SUBJECT: Single Phase, 4800 Volt Distribution line
Reference No: 06654291/Sage/Gladwin/Hall

CU-255

Subject: **UGL071131/CU-255**
06654291/Sage/Gladwin/Hall
Single Phase, 4800 Volt Distribution Line Pole Attachment

NOTIFICATION OF PROPOSED LINE CONSTRUCTION REQUIRING COORDINATION WITH HVD AND/OR TRANSMISSION LINES

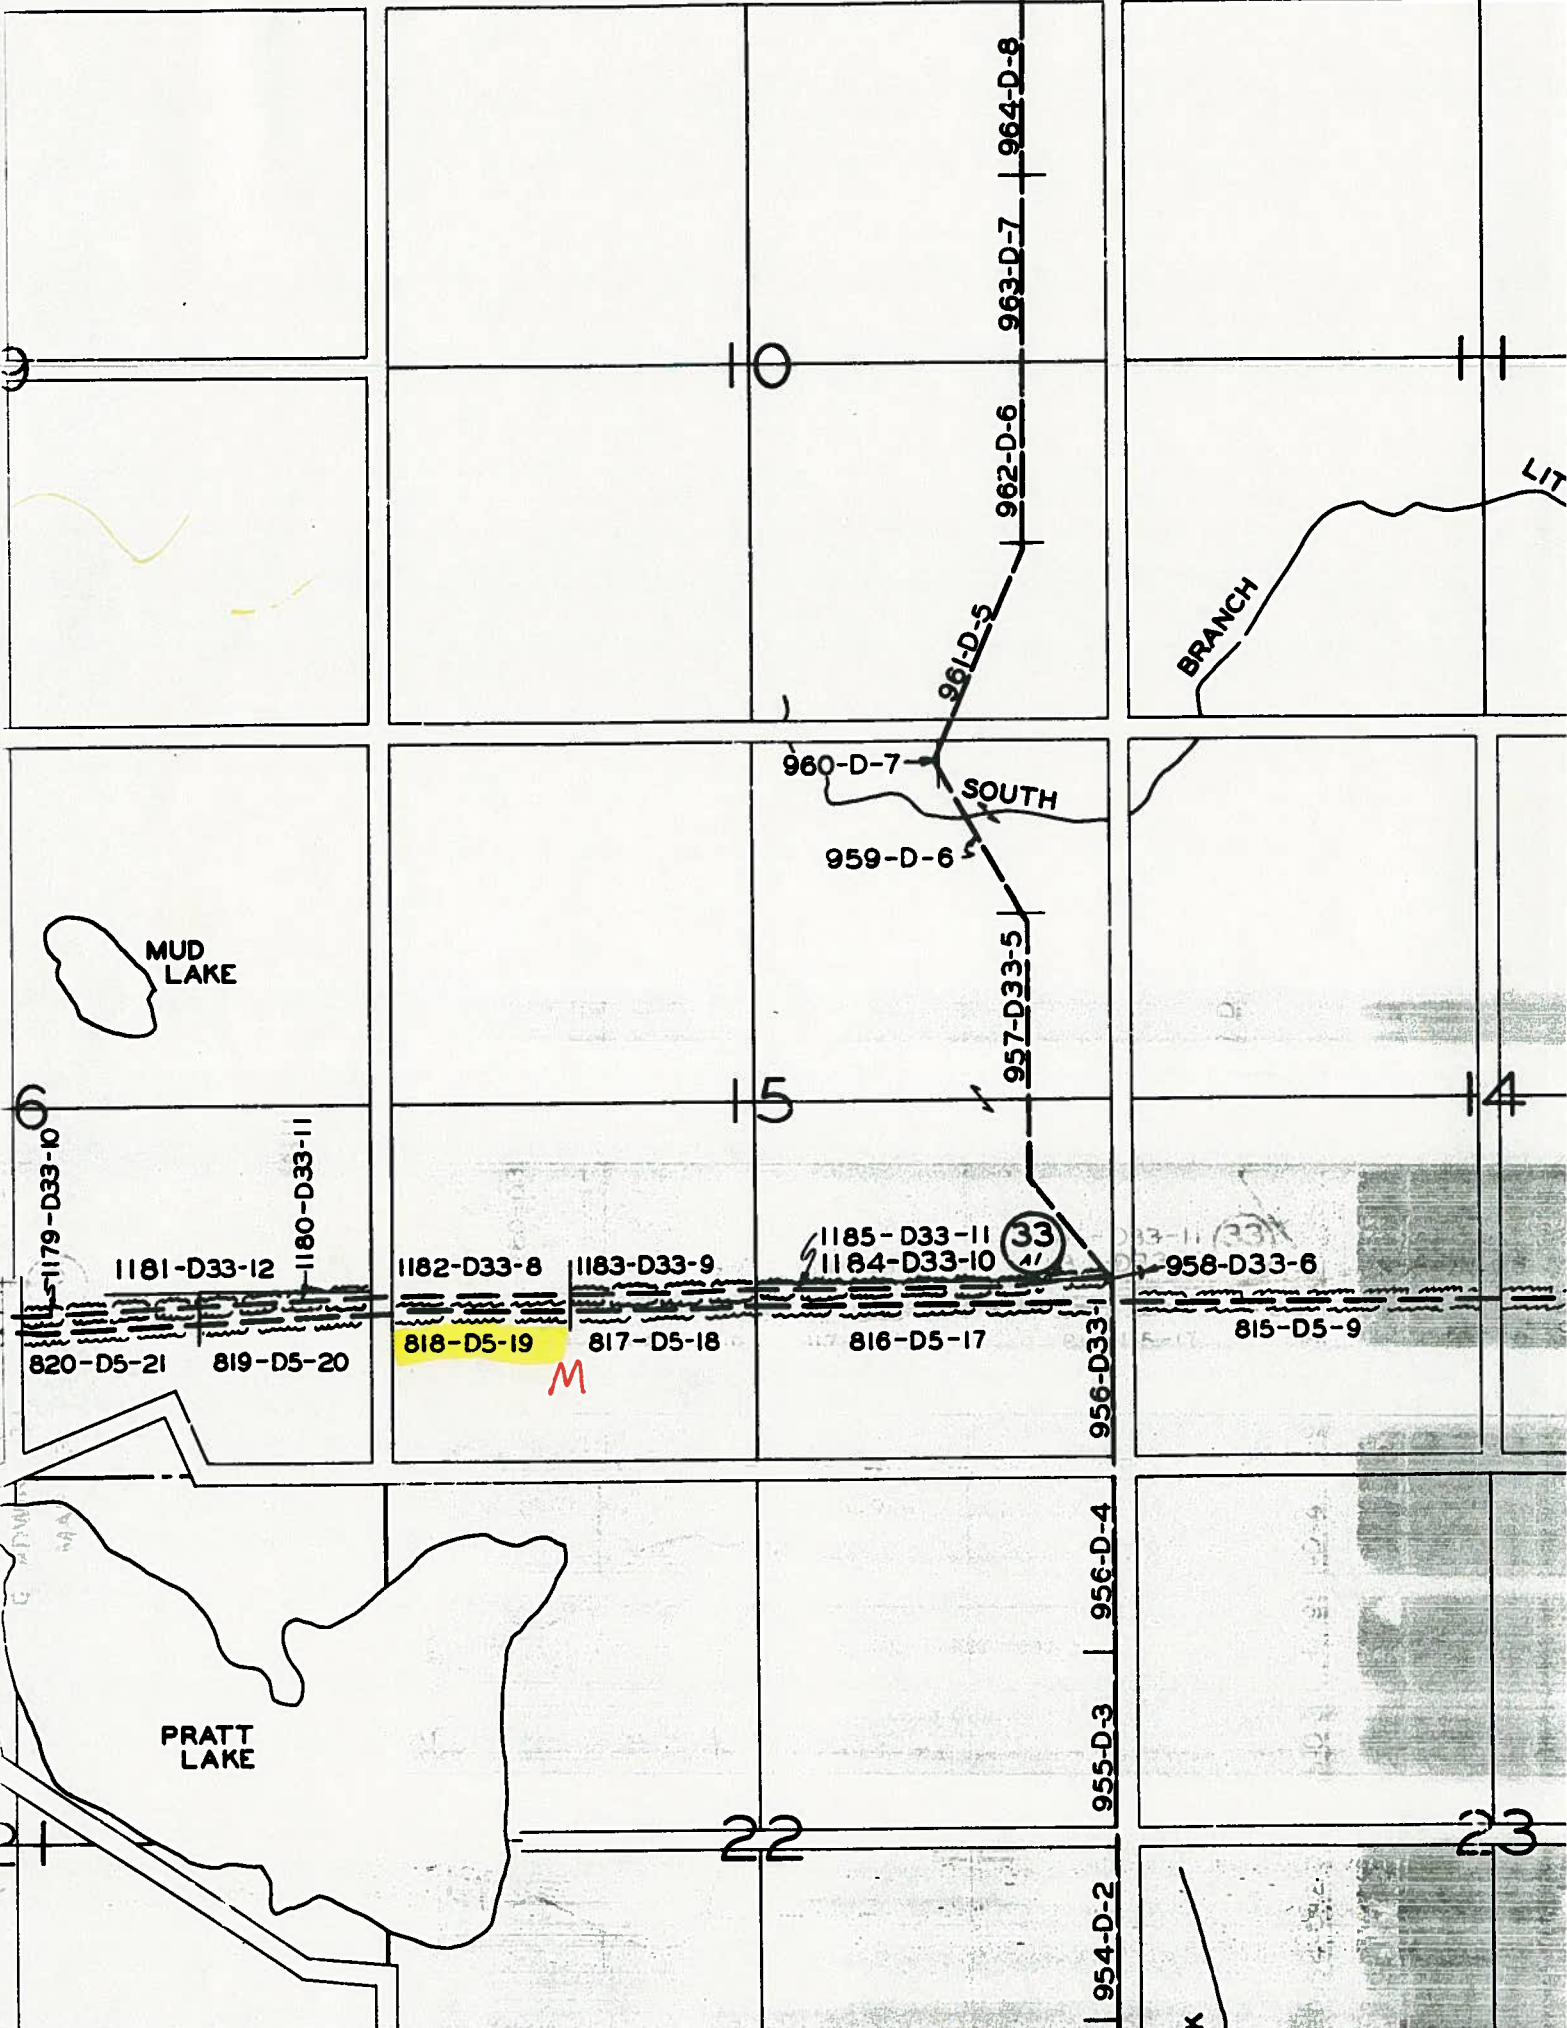
Install a distribution line. New distribution will cross under an existing transmission line. The distance below transmission is 10 feet. See attached 391 form, drawing, and plan and profile for details.

Distance Below Transmission 10'

METC lines are subject to the easement rights of METC. Your request has been forwarded to Real Estate for processing and will require a 30-day period prior to approval.

This request is hereby approved
